# UNITED STATES PATENT AND TRADEMARK OFFICE

APPLICATION NO.	FILING DATE	FIRST NAMED INVENTOR	ATTORNEY DOCKET NO.	CONFIRMATION NO.
10/795,878	03/08/2004	Chi-Ming Huang	250913-1150	2105

<b>Office Action Summary</b>	<b>Application No.</b> 10/795,878	<b>Applicant(s)</b> HUANG ET AL.	
	<b>Examiner</b> Jason Uhlenhake	<b>Art Unit</b> 2853

## DETAILED ACTION

FIG. 9

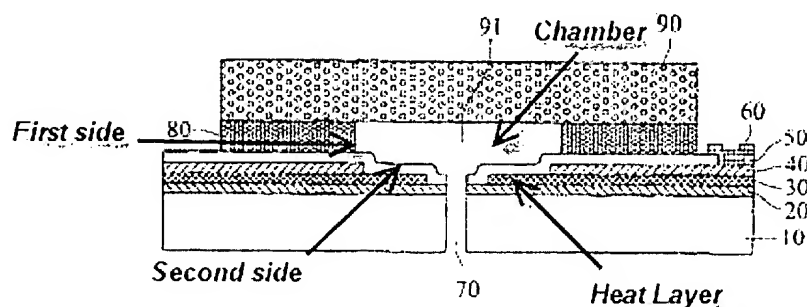
- ***regarding claim 1***, providing a substrate and a porous material (Figure 9; Column 2, Lines 12 – 31; Column 3, Lines 47 - 53)
- forming a heating layer on the substrate; forming a conductive layer on the substrate, wherein the conductive layer conducts a current to the heating layer, and a

- forming a chamber (91) for storing liquid above the heating area, wherein the chamber includes a first side and a second side, the first side faces the heating area, the second side is connected to the first side, and the chamber is formed with an exit, from which the liquid is dispensed, on the second side; (Figure 9)
- placing the porous material (90) on the chamber (91) so that the liquid flows into the chamber therethrough (Figure 9; Column 2, Lines 29 – 31)

- **regarding claim 11**, a substrate; heating layer disposed on the substrate to dispense liquid; conductive layer disposed on the substrate to conduct a current to the heating layer, wherein a heating area is defined by the conductive layer and the heating layer (Figure 9; Column 2, Lines 14 – 31; Column 3, Lines 21 – 35)
- chamber, disposed on the heating area, having a first side and a second side, wherein the first side faces the heating area, the second side is connected to the

- porous material disposed on the substrate, wherein the liquid flows into the chamber through the porous material (Figure 9; Column 2, Lines 29 – 31)

- forming an adhesive layer (80) on the conductive layer (40) (Figure 9)

- placing the porous material on the adhesive layer to form a chamber (91) for storing liquid, wherein the liquid flows into the chamber through the porous material, the chamber includes a first side and a second side, the first side faces the heating area, the second side is connected to the first side, and the chamber is formed with an exit, from which the liquid is dispensed, on the second side; (Figure 9)

- **regarding claim 18**, wherein the porous material (90) includes a groove by cutting (no structural limitation for an apparatus claim, therefore it is not given

- an adhesive layer (80) on the conductive layer (40) (Figure 9)

- porous material, disposed on the substrate, including a chamber (91), wherein the liquid flows into the chamber through the porous material, the chamber includes a first side and a second side, the first side faces the heating area, the second side is connected to the first side (Figure 9)

- ***regarding claim 4***, an adhesive layer (80) for the porous material (90) (Chen et al: Figure 9)
- a light-sensitive polymer (Park et al: Column 6, Lines 50 – 67; Column 7, Lines 1 – 10)

- ***regarding claim 10***, and adhesive layer (80) covered by the porous material (90) (Chen et al: Figure 9)

- ***regarding claim 14***, comprising and adhesive layer (80) disposed between the chamber and the porous material (90) (Figure 9)

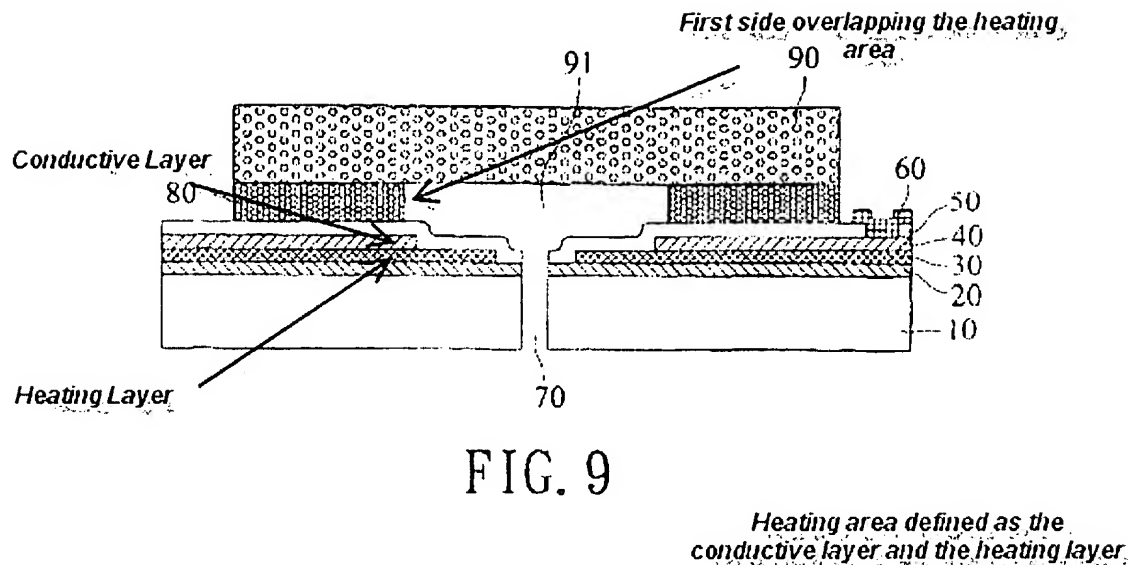
Applicant's arguments filed 10/26/2006 have been fully considered but they are not persuasive. Please see the above rejections regarding Chen et al. Applicant argues that the structure of Chen et al does not disclose that the first side is overlapped with the heating area. However, the first side is overlapping the heating area as claimed (Figure 9). The heating area is defined by the conductive layer (40) and the heating layer (30) as disclosed by the specification and currently amended claim. The current claim does not state that the first side completely overlaps the heating area and does not clearly define the structure of the heating area.
